2.12 Station Electrical Systems

The information in this section of the reference ABWR DCD, including all subsections, figures and tables, is incorporated by reference with the following departures.

STD DEP T1 2.12-1 (Tables 2.12.1, 2.12.12, 2.12.14 and 2.12.15)

STD DEP T1 2.12-2 (Figure 2.12.15)

Figure 2.12.15 Instrument and Control Power Supply

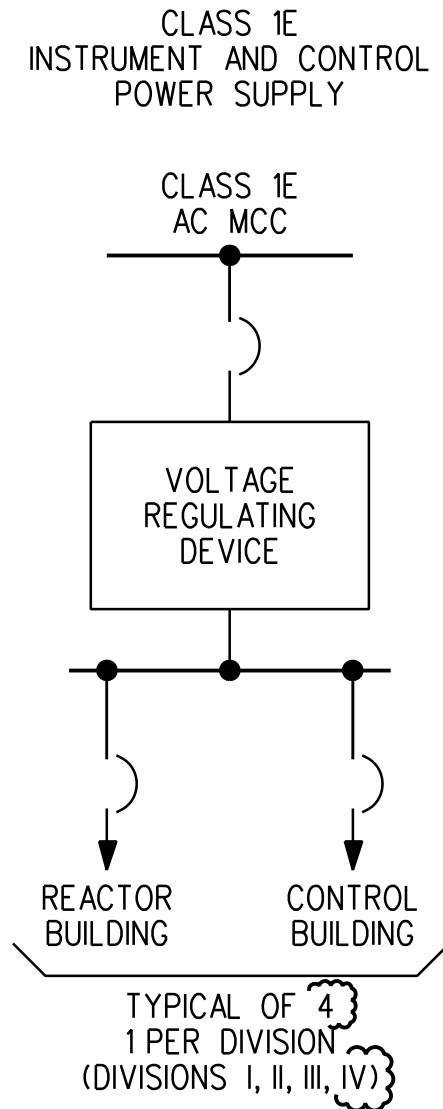
STD DEP T1 2.12-2

The Class 1E Instrument and Control Power Supply consists of ~~three~~ four divisions (Division I, II, ~~and III~~, and IV) of interruptible power supplies with their respective distribution panels. Each Class 1E power supply provides interruptible, regulated AC power to Class 1E circuits which do not require continuity of power during a loss of preferred power (LOPP).
